**FINAL EXPRESS TERMS
FOR
PROPOSED BUILDING STANDARDS
OF THE
DIVISION OF THE STATE ARCHITECT (DSA-AC)

REGARDING THE CALIFORNIA BUILDING CODE
CALIFORNIA CODE OF REGULATIONS, TITLE 24, PART 2

2013 CALIFORNIA BUILDING CODE
INTERVENING CODE CYCLE**

Figure 11B-307.4.1
Guy Braces

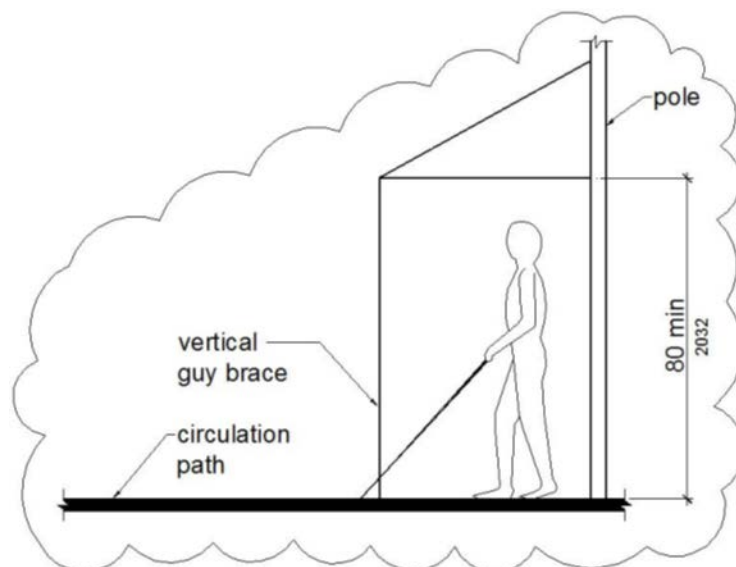
11B-307.4.1 Guy braces. *Where a guy support is used within either the width of a circulation path or 24 inches maximum outside of a circulation path, a vertical guy brace, sidewalk guy or similar device shall be used to prevent a hazard or an overhead obstruction.*

Figure **11B-406.2.2**
Sides of Curb Ramps

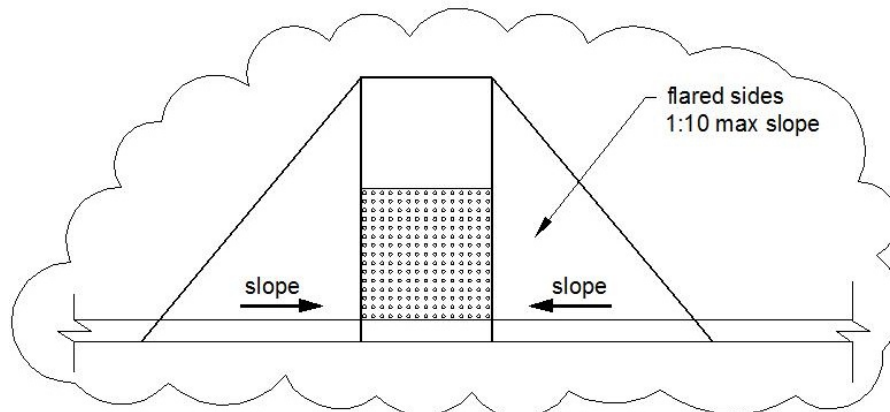
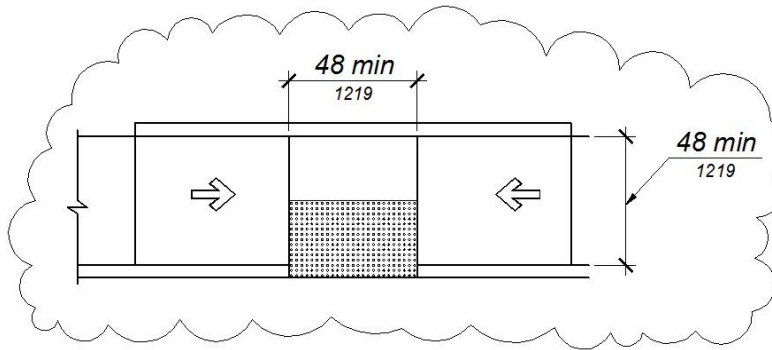
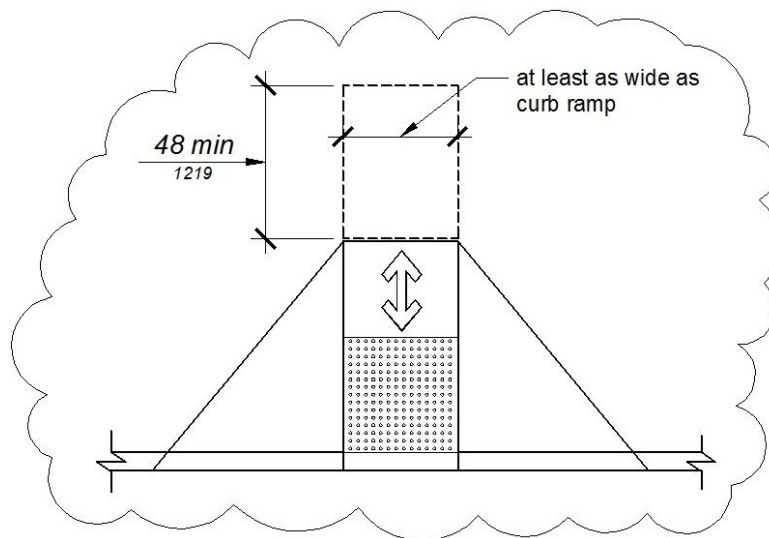
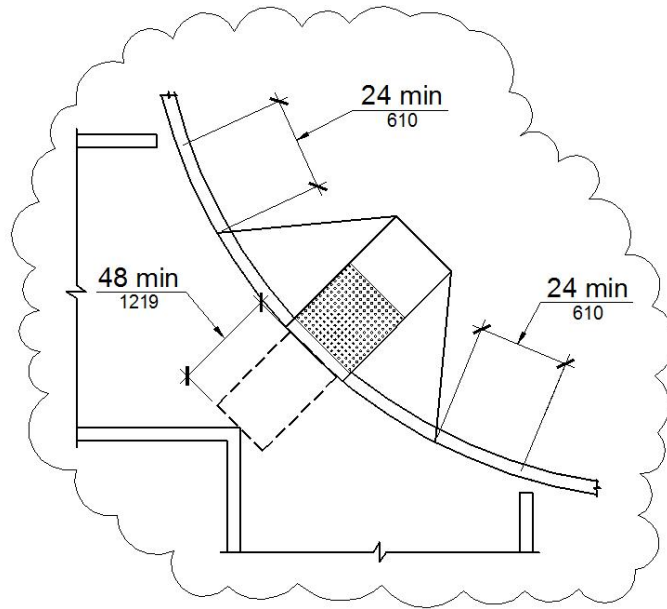
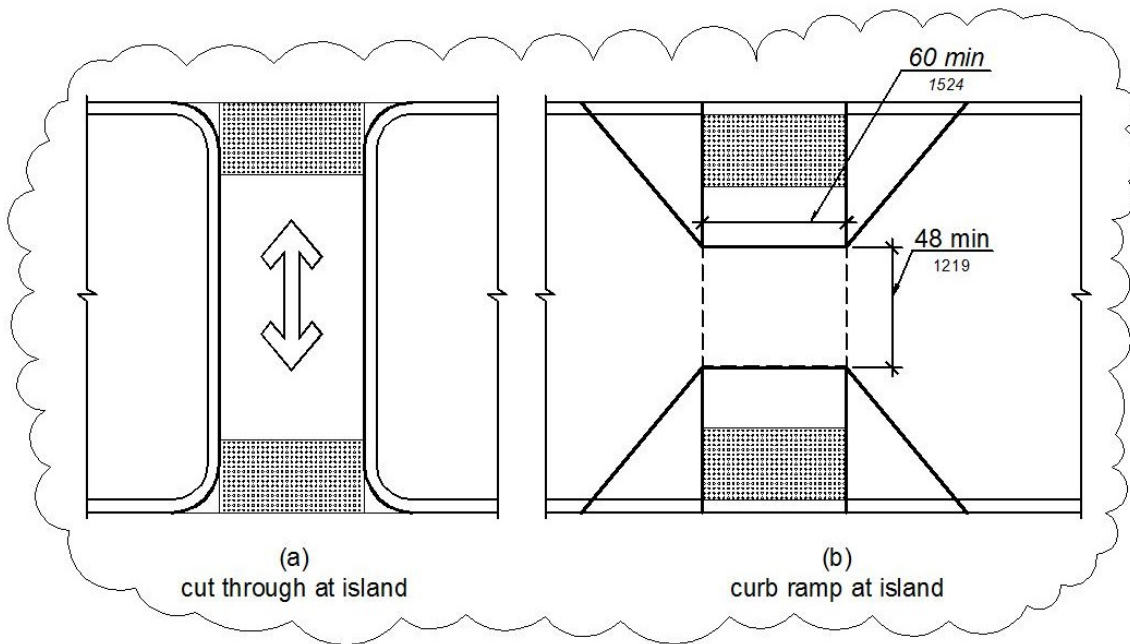
Figure ~~11B-406.5.7~~ **11B-406.5.8**
Counter Slope of Surfaces Adjacent to Curb Ramps

Figure 11B-411.2.1.2.3
Destination-Oriented Elevator Accessibility Function Button Indication

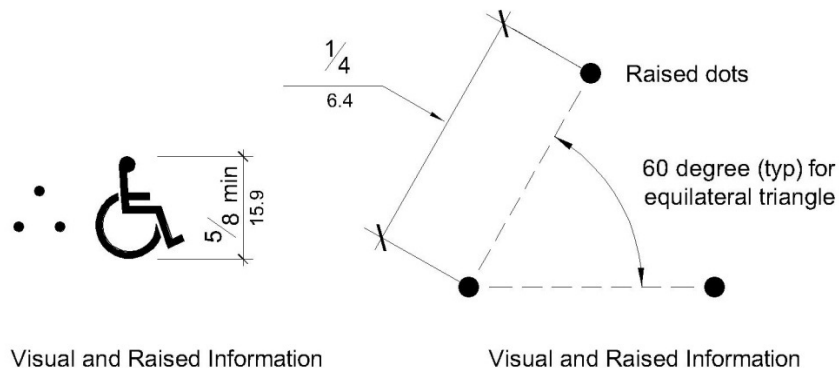
11B-411.2.1.2.3 Accessibility function button. The accessibility function button shall be identified by the International Symbol of Accessibility and a raised indication. The International Symbol of Accessibility shall comply with Section 11B-703.7.2.1, and shall be 5/8 inch (15.9 mm) minimum in height. The indication shall be three raised dots. Each dot shall have a base diameter of 0.059 inch (1.5 mm) minimum and 0.063 inch (1.6 mm) maximum and a height of 0.025 inch (0.6 mm) minimum and 0.037 inch (0.9 mm) maximum. The dots shall be spaced 1/4 inch (6.4 mm), measured center to center, in the form of an equilateral triangle with a vertex pointing up. The accessibility function button shall not be provided with a key repeat function.

Figure 11B-411.2.3
Floor Designation and Car Designation Signs on Jambs
of Destination-Oriented Elevator Hoistway Signs

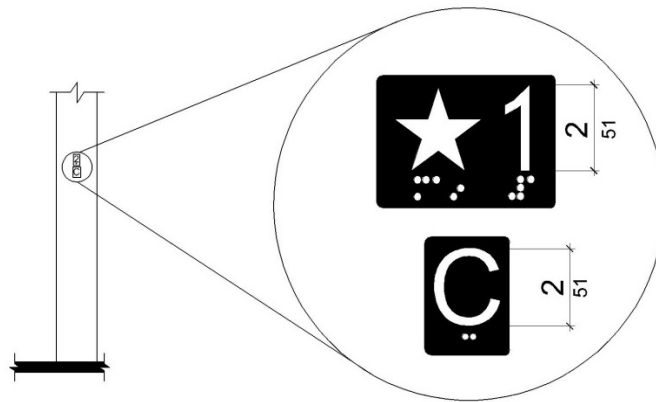
11B-411.2.3.1 Floor designation signs. Floor designation signs complying with Sections 11B-703.2 and 11B-703.4.1 shall be provided on both jambs of elevator hoistway entrances. Signs shall be provided in both raised characters and Braille. Raised characters shall be 2 inches (51 mm) high. A raised star placed to the left of the floor designation, shall be provided on both jambs at the main entry level. The outside diameter of the star shall be 2 inches (51 mm) and all points shall be of equal length. Raised characters, including the star, shall be white on a black background. Braille complying with Section 11B-703.3 shall be placed below the corresponding raised characters and the star. The Braille translation for the star shall be "MAIN". Applied plates are acceptable if they are permanently fixed to the jamb.

11B-411.2.3.2 Car designation signs. Car designation signs complying with Sections 11B-703.2 and 11B-703.4.1 shall be provided on both jambs of the hoistway immediately below the floor designation. Signs shall be provided in both raised characters and Braille. Raised characters shall be 2 inches (51 mm) high. Raised characters shall be white on a black background. Braille complying with Section 11B-703.3 shall be placed below the corresponding raised characters. Applied plates are acceptable if they are permanently fixed to the jamb.

Figure 11B-407.2.3.1
Floor Designations on Jambs of Elevator Hoistway Entrances

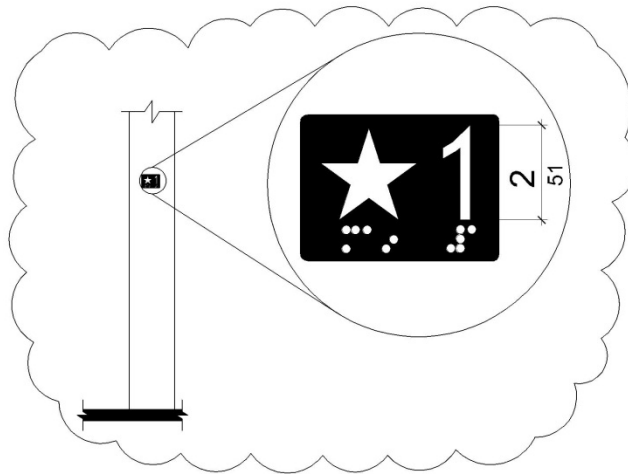
11B-407.2.3.1 Floor designation. Floor designations complying with Sections 11B-703.2 and 11B-703.4.1 shall be provided on both jambs of elevator hoistway entrances. Floor designations shall be provided in both *raised* characters and Braille. *Raised* characters shall be 2 inches (51 mm) high. A *raised* star, *placed to the left of the floor designation*, shall be provided on both jambs at the main entry level. *The outside diameter of the star shall be 2 inches (51 mm) and all points shall be of equal length. Raised characters, including the star, shall be white on a black background. Braille complying with Section 11B-703.3 shall be placed below the corresponding raised characters and the star. The Braille translation for the star shall be "MAIN". Applied plates are acceptable if they are permanently fixed to the jamb.*

Figure 11B-407.2.3.2
~~Car Designations on Jambs of Destination-Oriented Elevator Hoistway Entrances~~

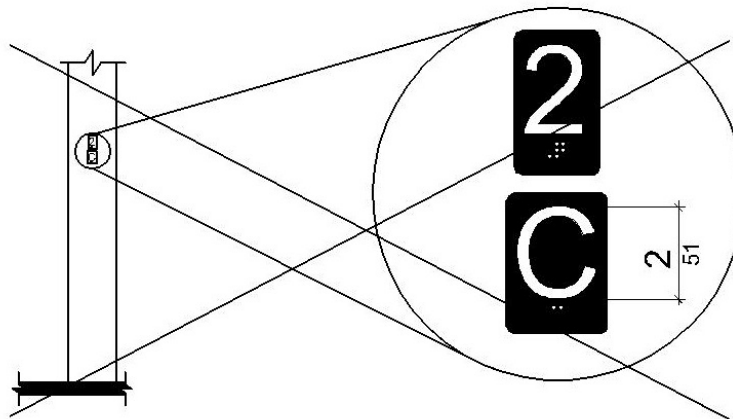
11B-407.2.3.2 Reserved. Car designations. Destination-oriented elevators shall provide tactile car identification complying with Sections 11B-703.2 and 11B-703.4.1 on both jambs of the hoistway immediately below the floor designation. Car designations shall be provided in both raised characters and Braille. Raised characters shall be 2 inches (51 mm) high. Raised characters shall be white on a black background. Braille complying with Section 11B-703.3 shall be placed below the corresponding raised characters. Applied plates are acceptable if they are permanently fixed to the jamb.

Figure 11B-604.7
Dispenser Outlet Location

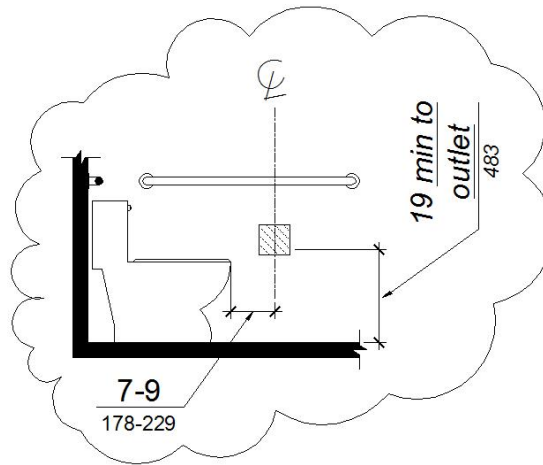
11B-604.7 Dispensers. Toilet paper dispensers shall comply with Section 11B-309.4 and shall be 7 inches (178 mm) minimum and 9 inches (229 mm) maximum in front of the water closet measured to the centerline of the dispenser. The outlet of the dispenser shall be *below the grab bar, 19 inches (483 mm) minimum* above the finish floor and shall not be located behind grab bars. Dispensers shall not be of a type that controls delivery or that does not allow continuous paper flow.

Figure 11B-703.8.5
Low Resolution VMS Signage Characters

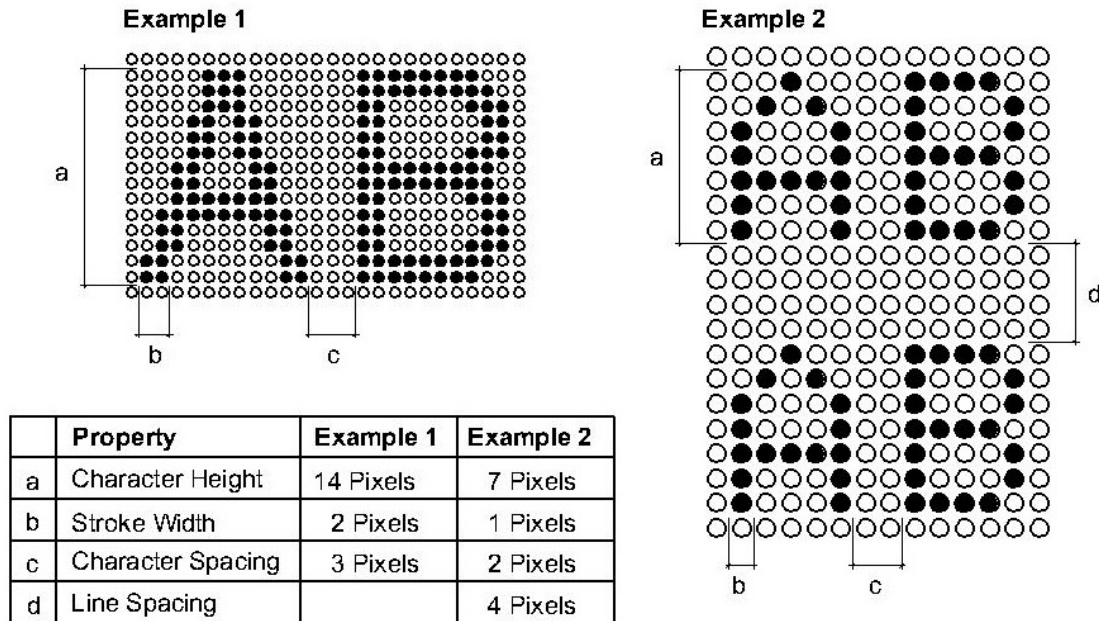
Table 11B-703.8.5 Pixel Count for Low Resolution VMS Signage

<u>Character Height</u>	<u>Character Width Range</u>	<u>Stroke Width Range</u>	<u>Character Spacing Range</u>
<u>7</u>	<u>5-6</u>	<u>1</u>	<u>2</u>
<u>8</u>	<u>6-7</u>	<u>1-2</u>	<u>2-3</u>
<u>9</u>	<u>6-8</u>	<u>1-2</u>	<u>2-3</u>
<u>10</u>	<u>7-9</u>	<u>2</u>	<u>2-4</u>
<u>11</u>	<u>8-10</u>	<u>2</u>	<u>2-4</u>
<u>12</u>	<u>8-11</u>	<u>2</u>	<u>3-4</u>
<u>13</u>	<u>9-12</u>	<u>2-3</u>	<u>3-5</u>
<u>14</u>	<u>10-13</u>	<u>2-3</u>	<u>3-5</u>
<u>15</u>	<u>11-14</u>	<u>2-3</u>	<u>3-5</u>

Figure 11B-604.8.1.4
Wheelchair Accessible Toilet Compartment Toe Clearance

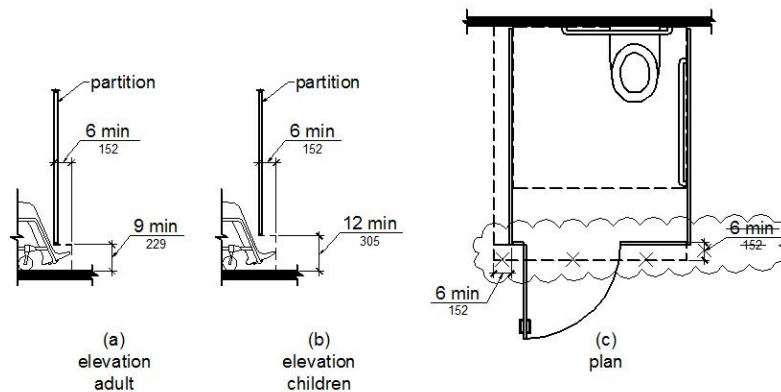
1B-604.8.1.4 Toe clearance. At least one side partition shall provide a toe clearance of 9 inches (229 mm) minimum above the finish floor and 6 inches (152 mm) deep minimum beyond the compartment-side face of the partition, exclusive of partition support members. *Partition components at toe clearances shall be smooth without sharp edges or abrasive surfaces.* Compartments for children's use shall provide a toe clearance of 12 inches (305 mm) minimum above the finish floor.

Exception: Toe clearance at the side partition is not required in a compartment greater than 66 inches (1676 mm) wide.
